**TO:** Planning Board  
**FROM:** Chandler Van Schaack, Case Manager  
**DATE:** December 17, 2015  
**SUBJECT:** **Call Up Item:** Staff Level Site Review (LUR2015-00088): Request to construct a new 3-story, 42,250 sq. ft. office building at 3107 Iris Ave. within the existing Bank of Boulder office park. The proposal also includes a request for a 16% parking reduction to allow for the reconfiguration of the existing parking area to provide 219 parking spaces where 262 spaces are required for the office park following the addition of the new office building. The project site is located within the BT-1 zone district.

**DECISION:** APPROVED WITH CONDITIONS  
**PROJECT NAME:** Bank of Boulder Park PUD Amendment  
**DESCRIPTION:** SITE REVIEW for a new 42,250 sq. ft. office building within the Bank of Boulder Park PUD.  
**LOCATION:** 3107 Iris Ave.  
**COOR:** N06W03  
**LEGAL DESCRIPTION:** Lot 2A, Replat of Lots 2 and 3, Bank of Boulder Park, County of Boulder, State of Colorado  
**APPLICANT:** Erik Hartronft  
**OWNER:** DellaCava Family LLC  
**APPLICATION:** Site Review, LUR2015-00088  
**ZONING:** BT-1  
**CASE MANAGER:** Chandler Van Schaack  
**VESTED PROPERTY RIGHT:** NO;

Sheet  
L1.1  
of Sheets

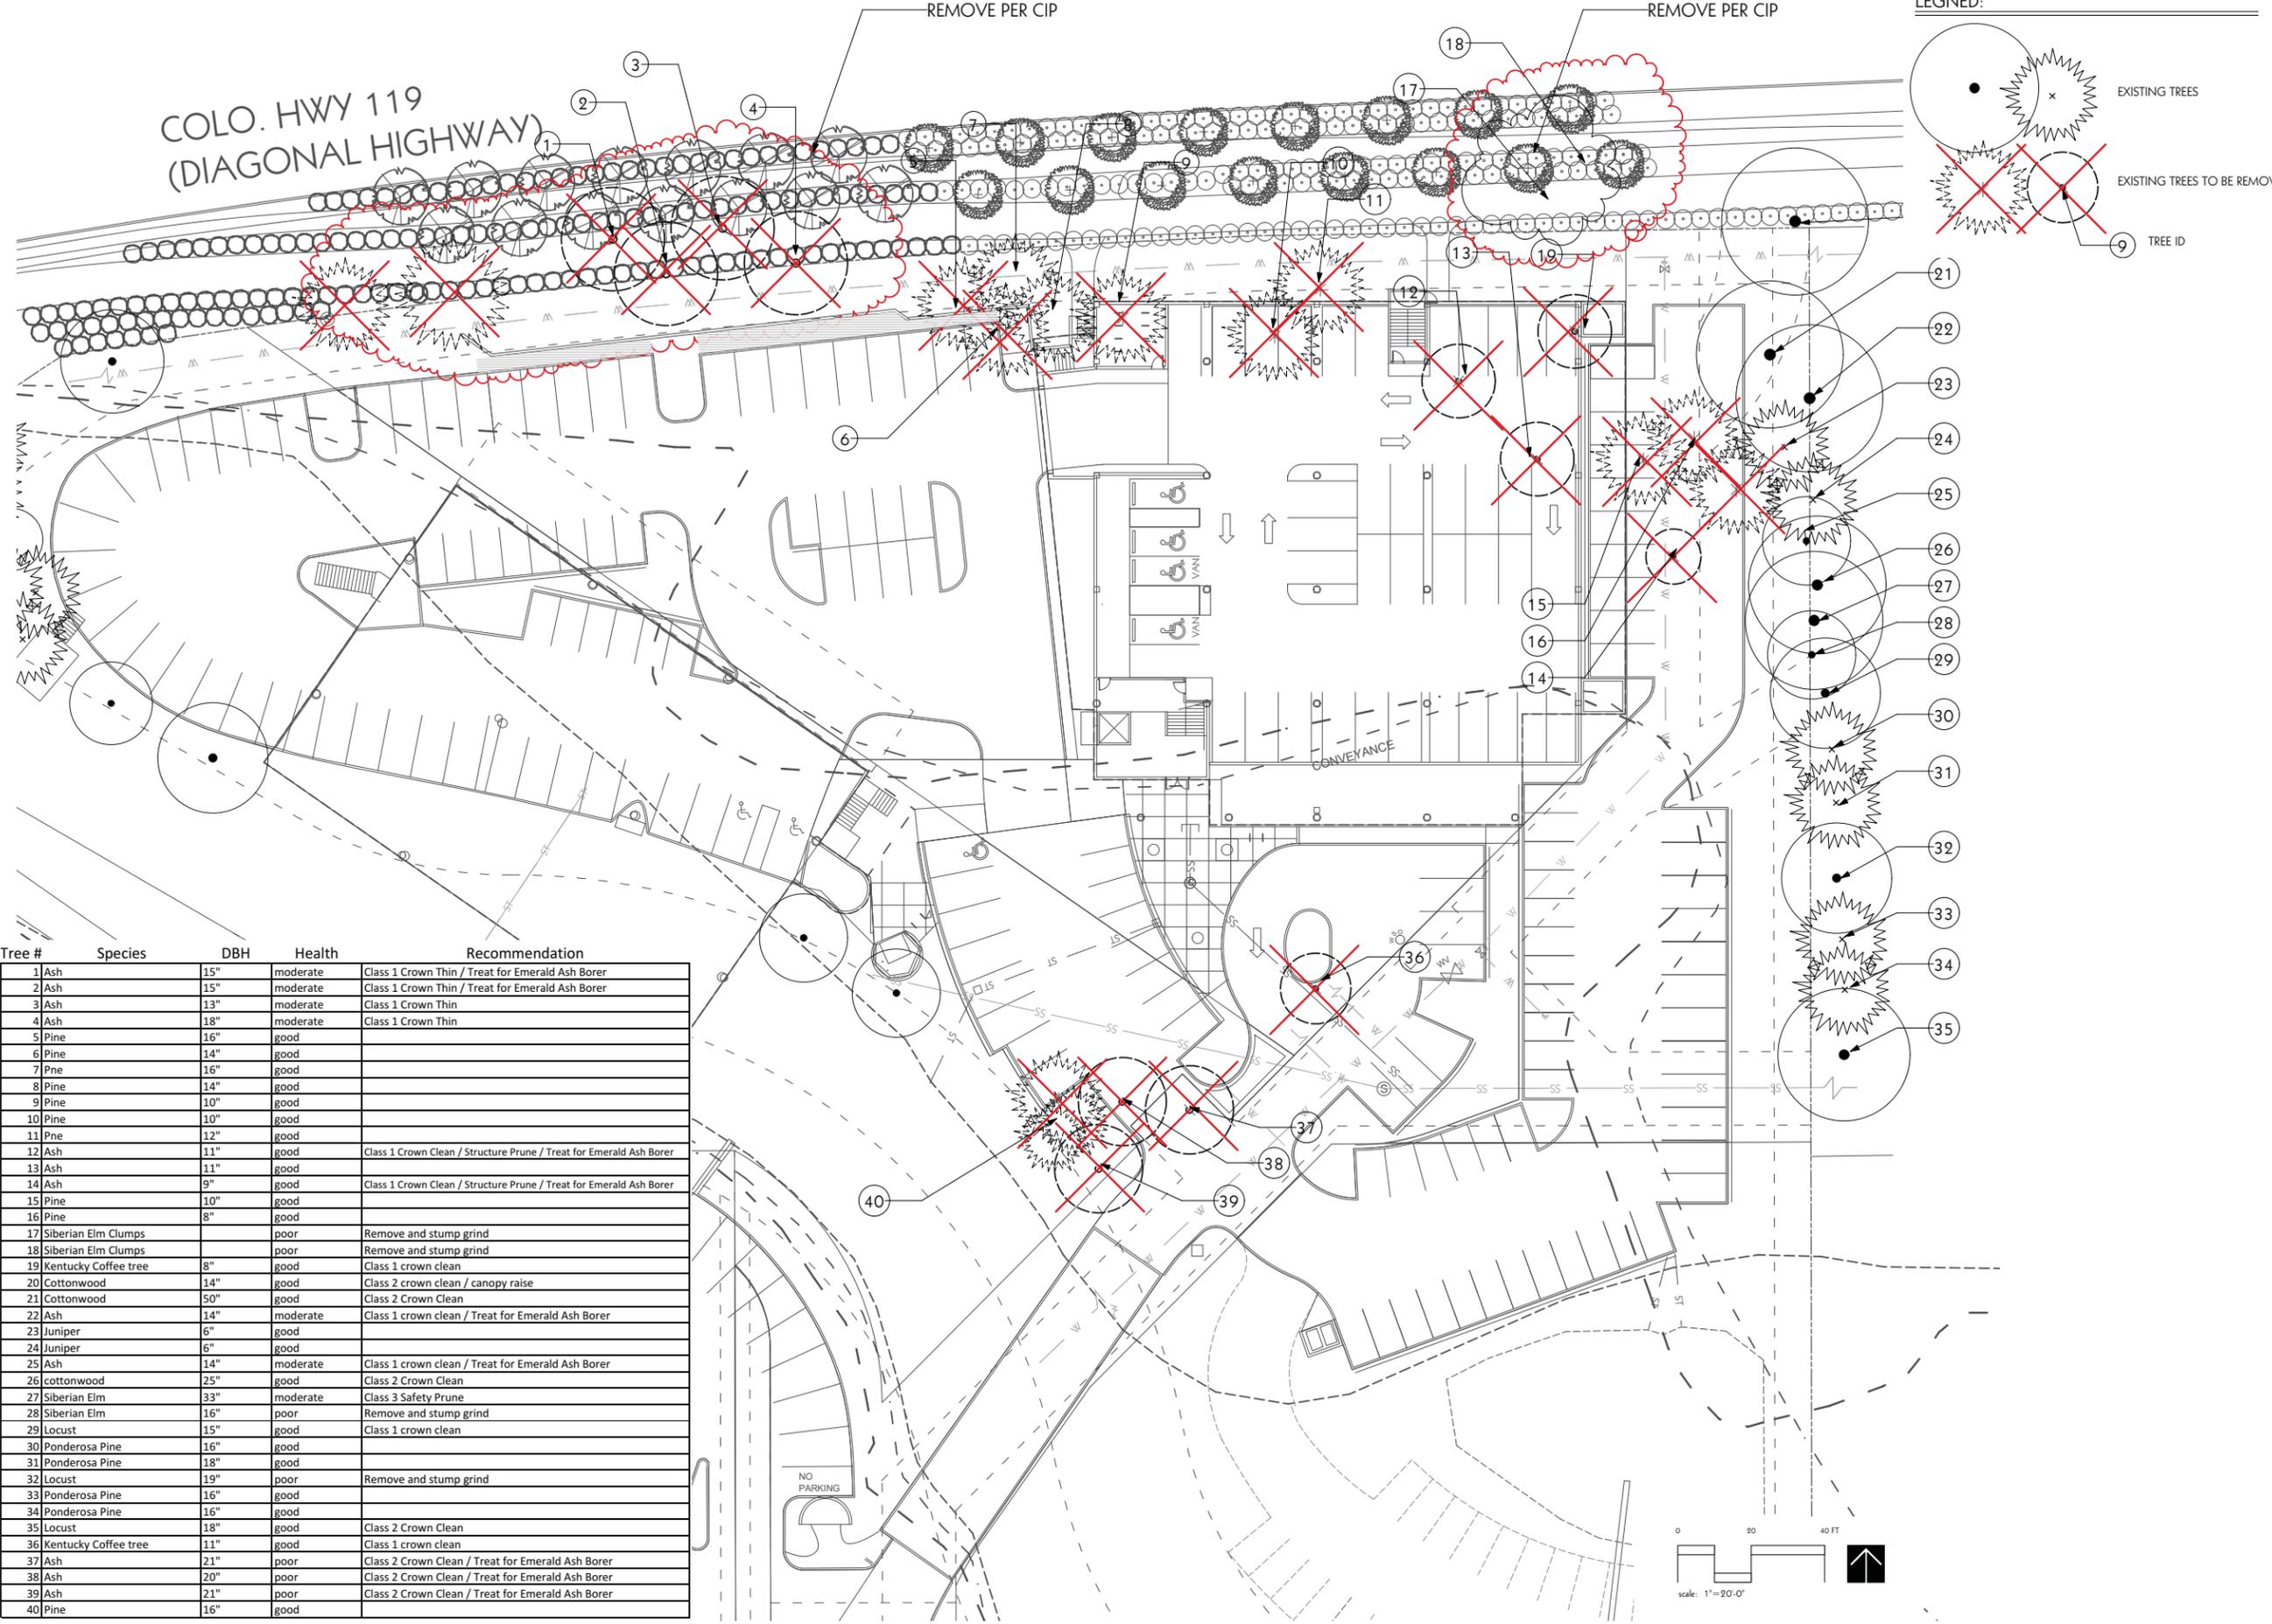
2. The plan associated with the tree inventory and information on who performed it. Please note that the removal of public street trees requires approval from the City Forester and will incur mitigation fees per section 6-6-6 B.R.C. 1981.

Sheet  
**L2.1**  
of Sheets

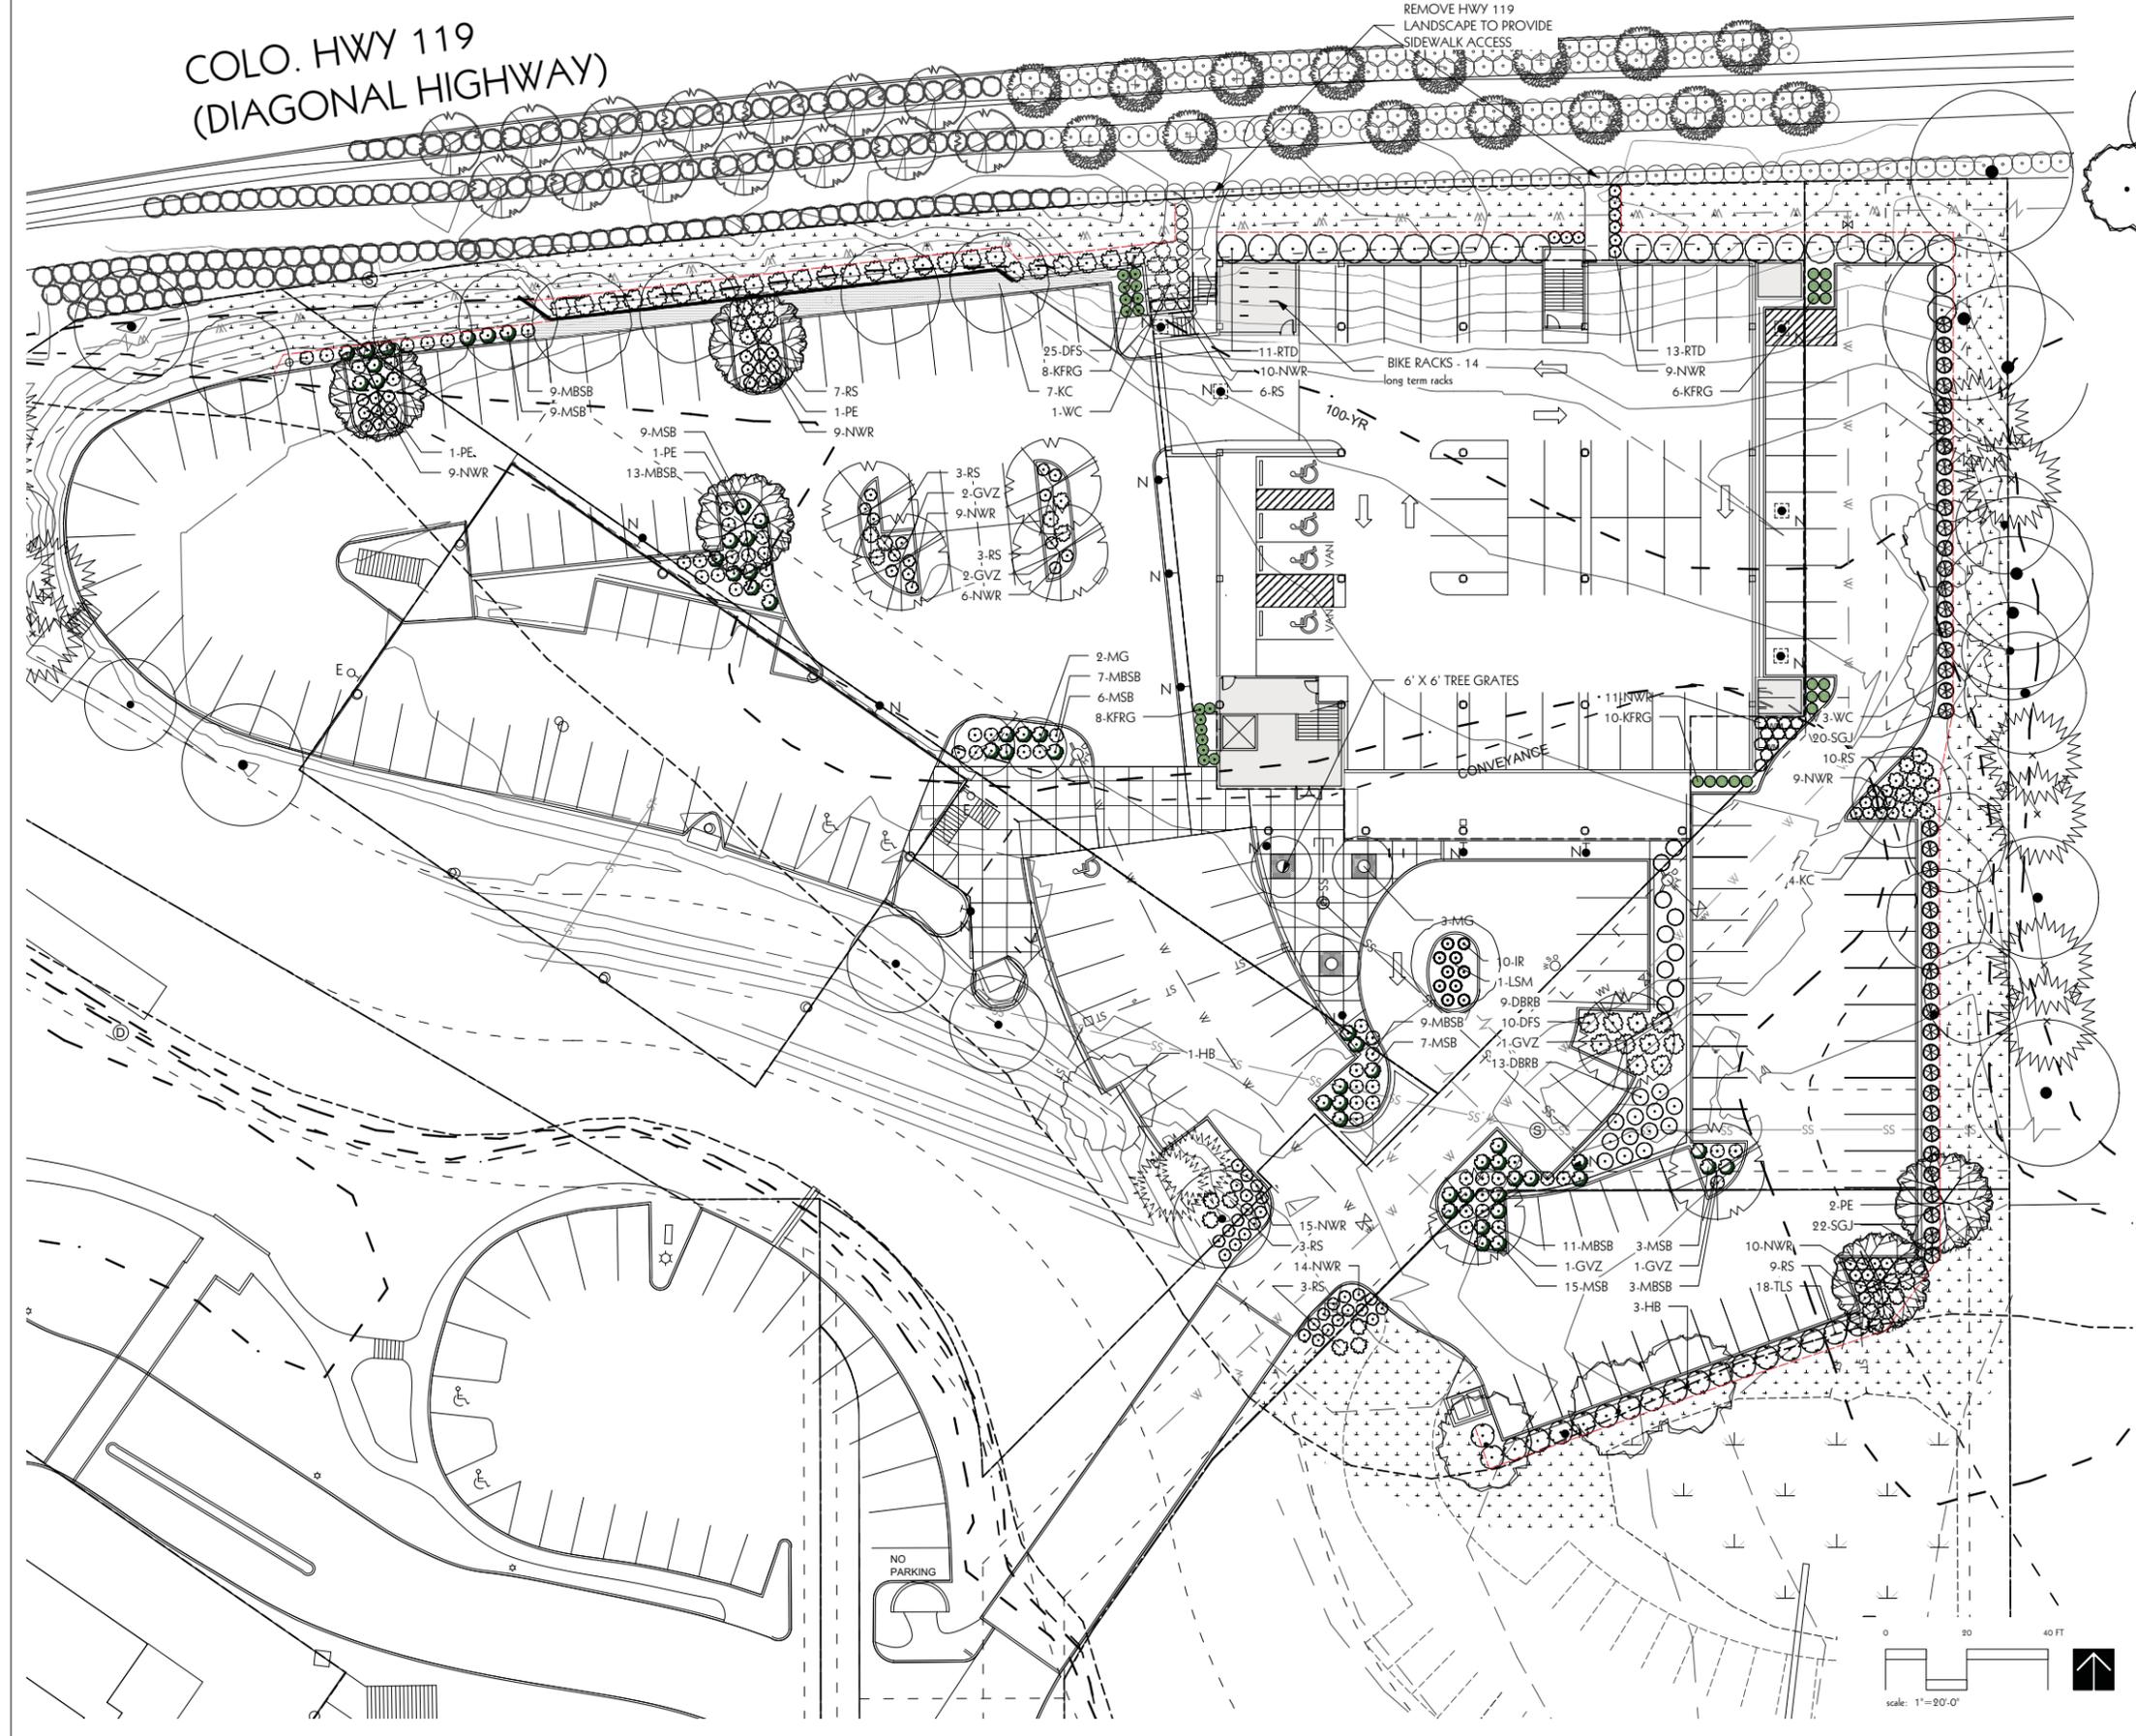
See section 9-9-12(d) for a list of general requirements. This list forms the basis of what is typically included on a landscape plan. The landscape requirements chart if of particular importance and shall call out any requested modifications and justification for the modification. Update the requested modifications section of the application

accordingly. To meet criteria, it appears additional plant material is needed.

5. Illustrate all proposed bike racks on the plans.
6. Illustrate all proposed parking lot screening from the street and from adjacent properties per section 9-9-14(c) B.R.C. 1981.

9. Add the existing and proposed utilities to the landscape plans and coordinate any conflicts. Existing and proposed sanitary sewer need attention.
10. Under General Notes on Sheet L1.00, delete No 1, 3, and 6 which are not applicable. Renumber. Update Note No. 9 regarding mulch to specify that no fabric shall be used. Many of the proposed beds are relatively small and fabric is of no benefit.
11. Coordinate the proposed streetscape with the adjacent capital improvement project (CIP). Contact Jason Fell (303-441-4007; [fellj@bouldercolorado.gov](mailto:fellj@bouldercolorado.gov)) for the final approved plans and illustrate the area that interfaces with the project property. If any part of the project is meeting landscape requirements through the CIP, please call it out in the requirements chart.

Sheet  
**A2.10**

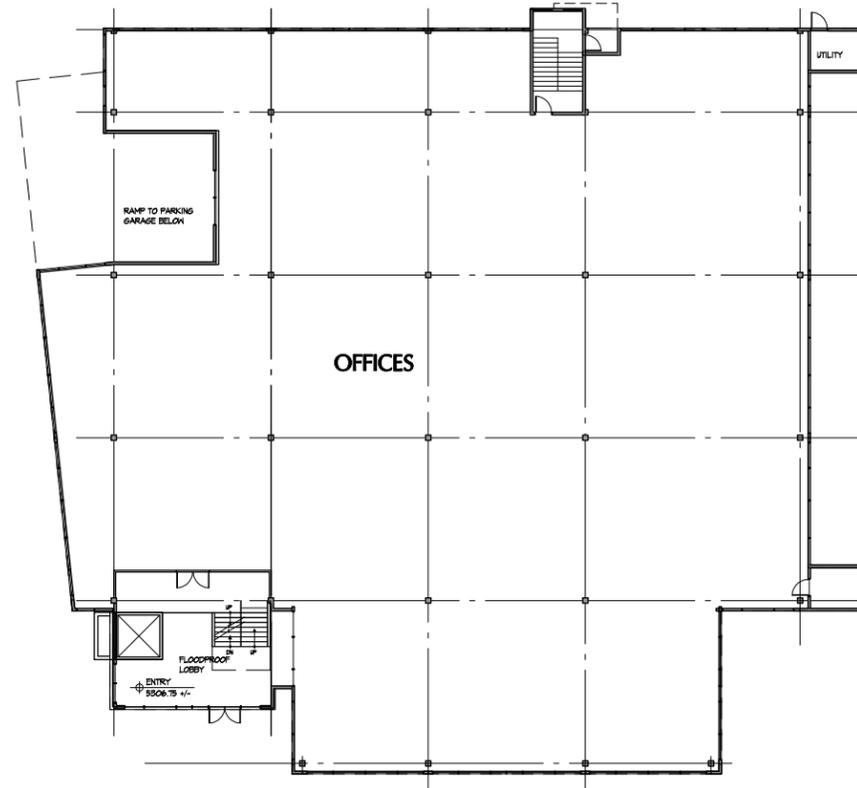
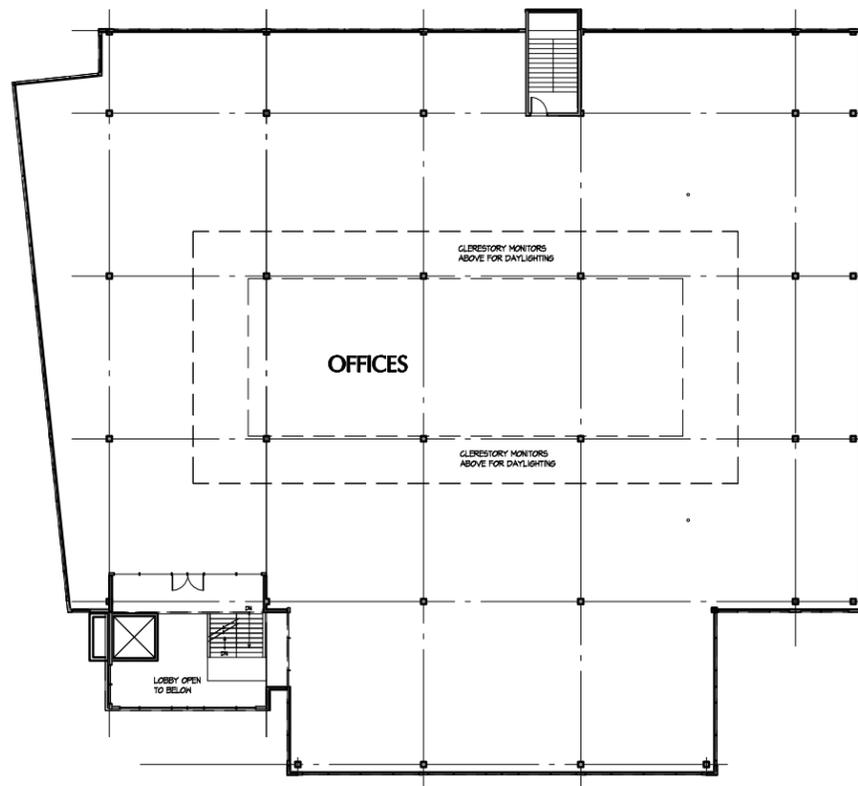
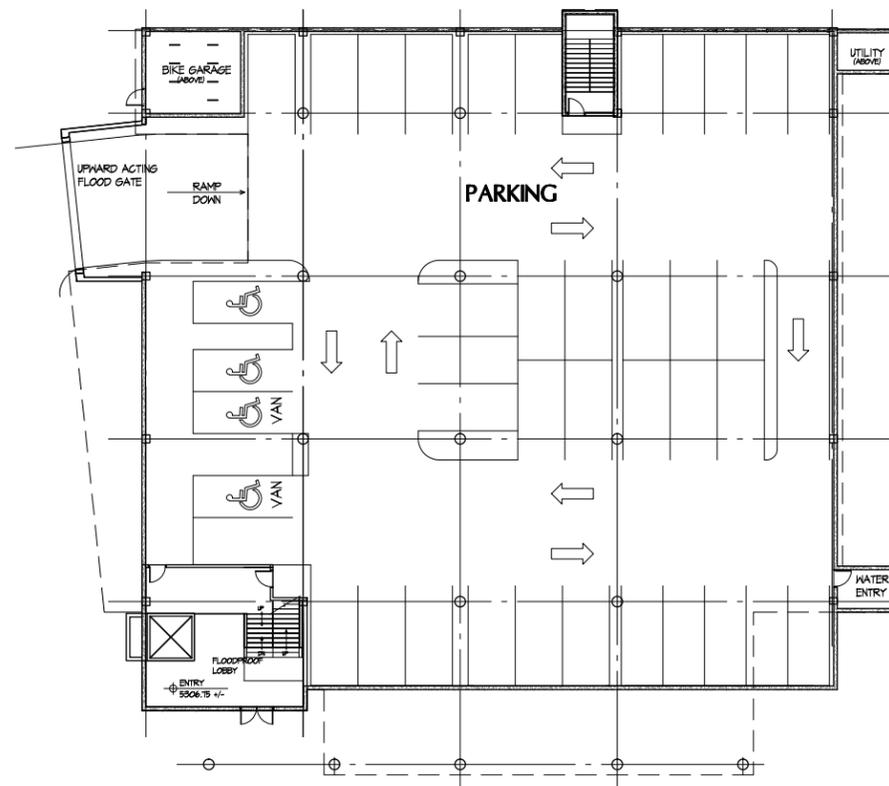
2. The current plans show an 8-foot “clerestory monitor” structure on the rooftop surrounding the proposed mechanical equipment. Section 9-16, B.R.C. defines an appurtenance as:

While typically mechanical equipment is able to meet the requirements for an “appurtenance” and is therefore able to exceed the 35 foot height limit, an 8-foot clerestory would not necessarily meet the requirements and may therefore not be allowed to exceed the maximum permitted building height of 35 feet. If the clerestory structure is to exceed 35 feet in height on the revised plans, it will be necessary to demonstrate that it meets the criteria for appurtenances found in [section 9-7-7](#) of the Boulder Revised Code, included below:

3. The proposed plans also indicate a “Parapet Max Height” of 18 inches above the roof line. Note that in order to include a parapet which exceeds the maximum allowable building height it will be necessary to demonstrate that the parapet *“is necessary to accommodate rooftop drainage or to provide fire protection”* as required by section 9-7-7(a)(5), B.R.C. 1981.

Sheet  
**A3.10**

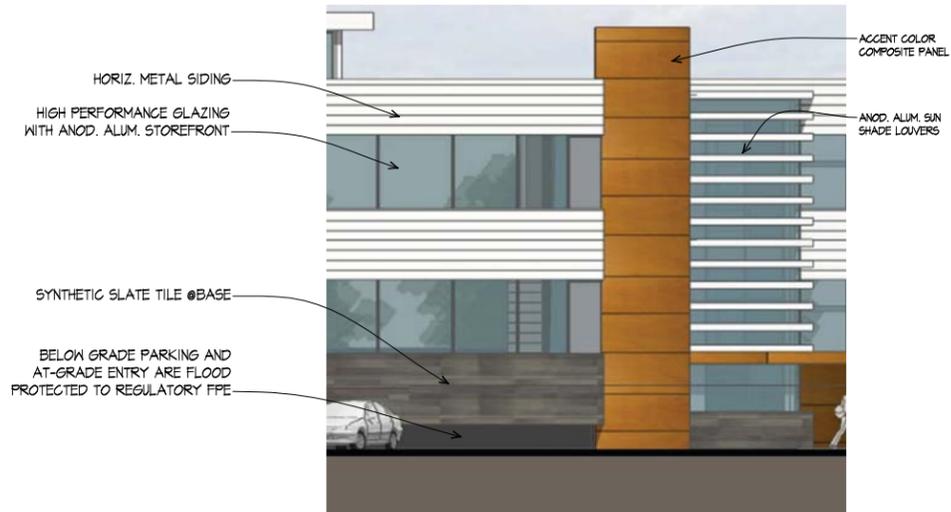
1. Staff finds that while the architecture of the proposed building appears to be in keeping with the existing buildings on the site as well as the intended architecture per the original PUD approval, the proposed materials are not in keeping with the intended design character of the buildings, which is described as *“concrete for the supporting structure and a light weight cantilevered structure above constructed of wood and/or steel, similar to the existing building.”* The applicant should revise the proposal to include materials similar to the existing buildings located on the site. The applicant should also note that in order to meet subsection 9-2-14(h)(2)(F)(xii) of the site review criteria, which requires that *“exteriors of buildings present a sense of permanence through the use of authentic materials such as stone, brick, wood, metal or similar products and building material detailing,”* stucco should be used primarily as an accent material rather than a primary building material as currently shown.
